PALISADES PLANT SGRR  
(Instructions for Entering Revision 4)

PALISADES PLANT SGRR

HOT SPOT  
HEAT TRANSFER COEFFICIENT  
FOR 2060 PSIA  
Figure E-4.2-1

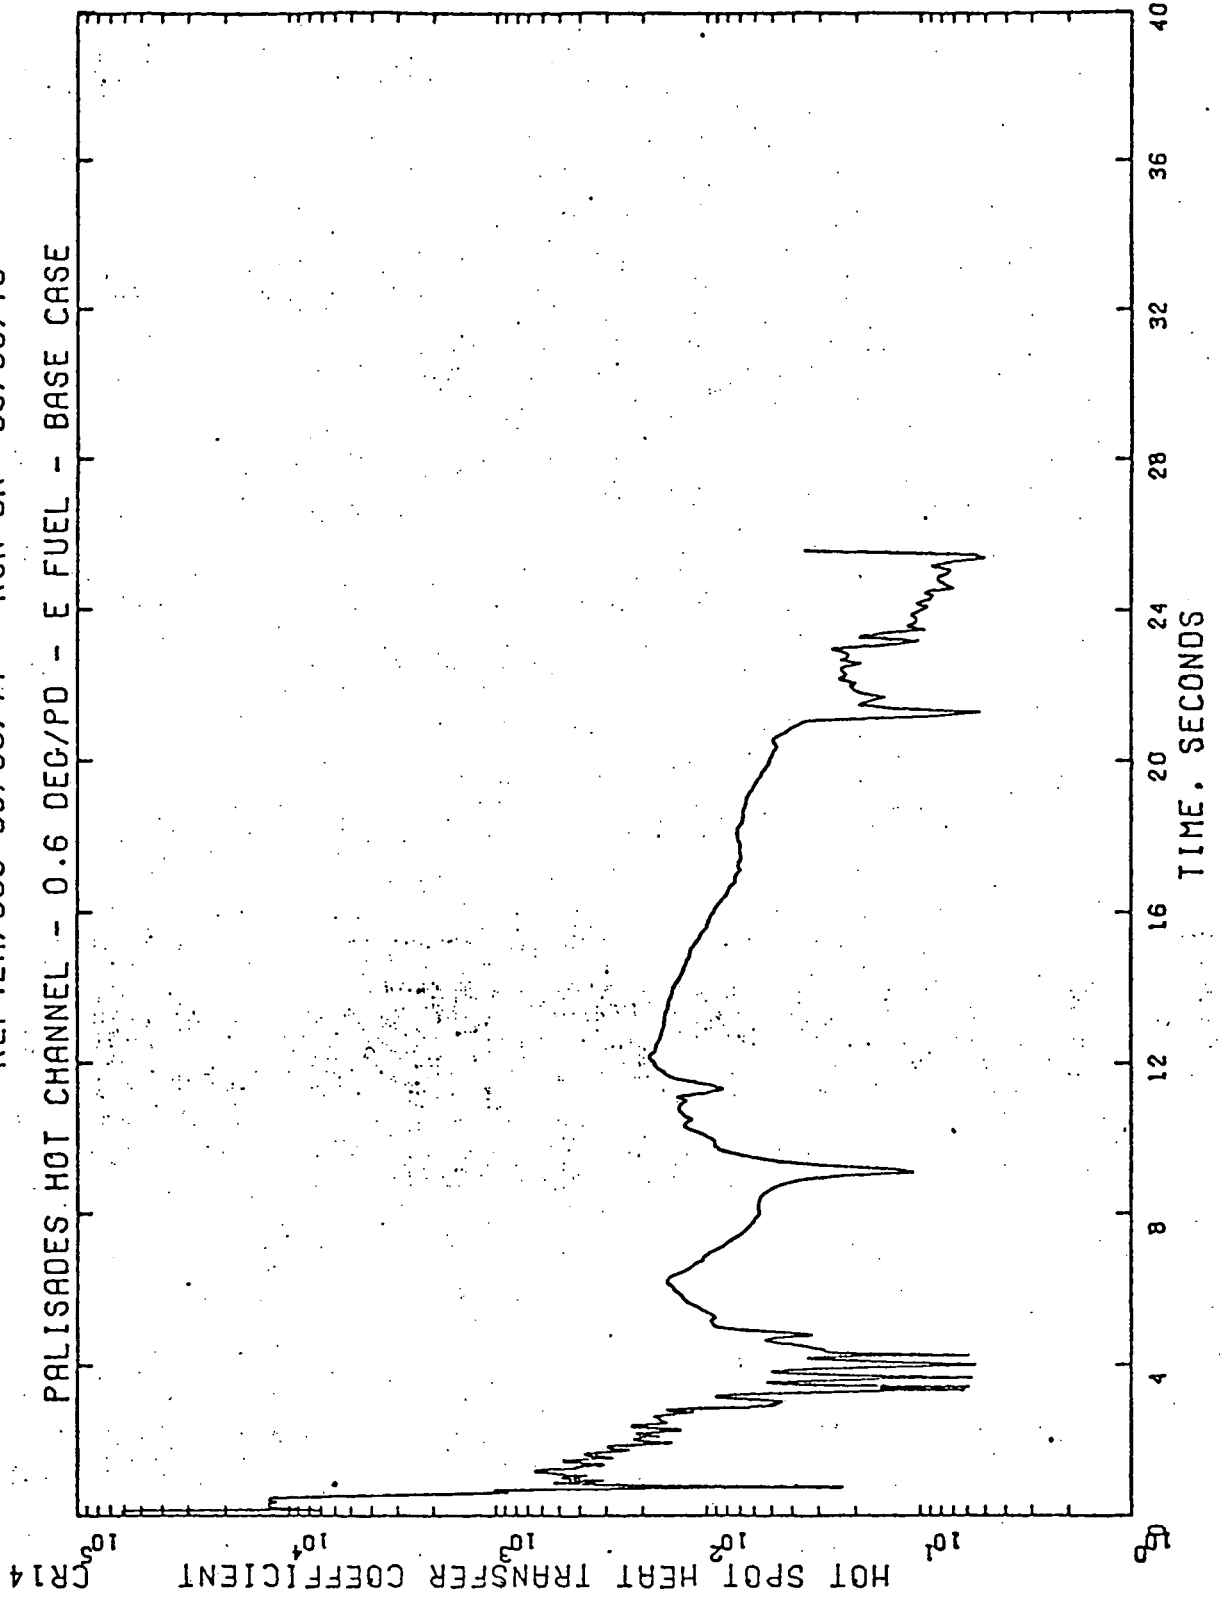
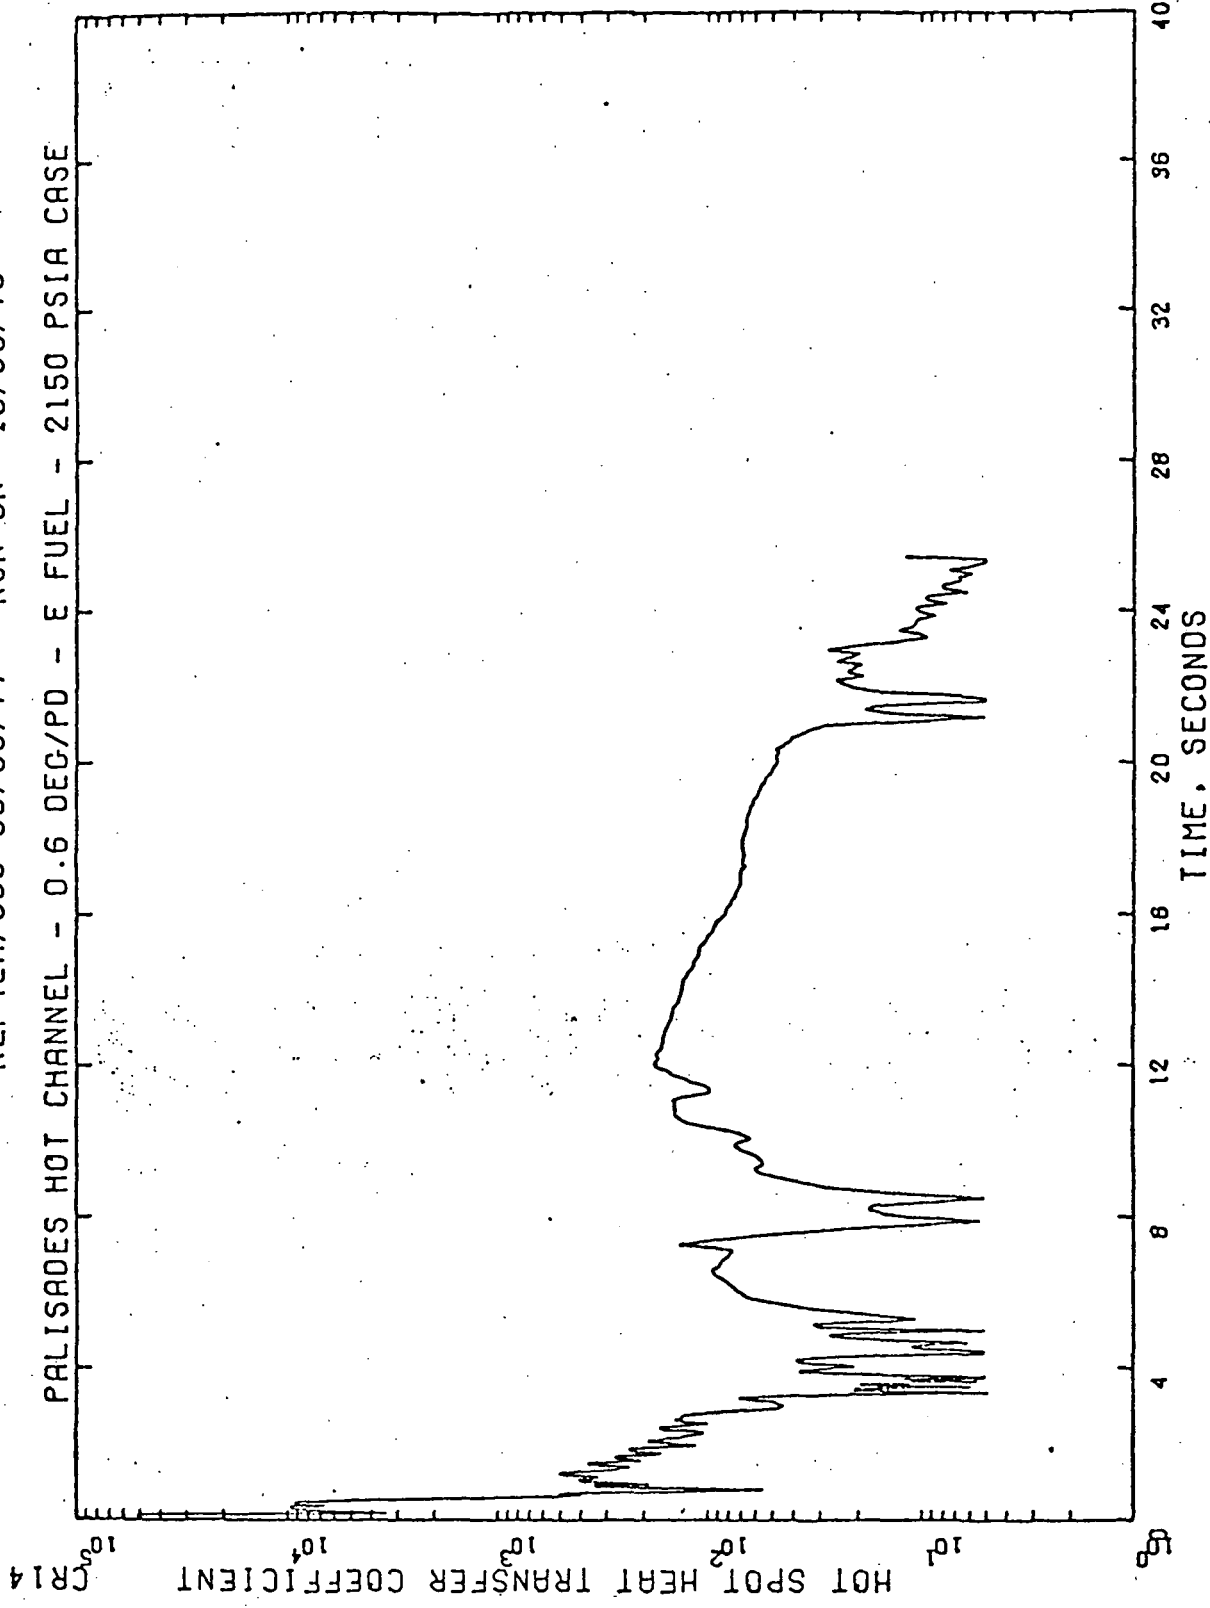
E-4.2 In Section 6.1.3 explain the effect of primary system pressure on blowdown, reflood, and peak clad temperature.

The major effect of increased primary system pressure was observed during the blowdown phase of the LOCA. With a higher pressure (2,150 versus 2,060 psia), flow through the core and hot assembly during blowdown was degraded sufficiently to result in poorer fuel rod heat transfer during blowdown and ultimately a higher peak clad temperature. For comparison purposes, the calculated heat transfer coefficient at the hot spot in the core is shown in Figures E-4.2-1 and E-4.2-2 for the base case and for the 2,150 psia case, respectively.
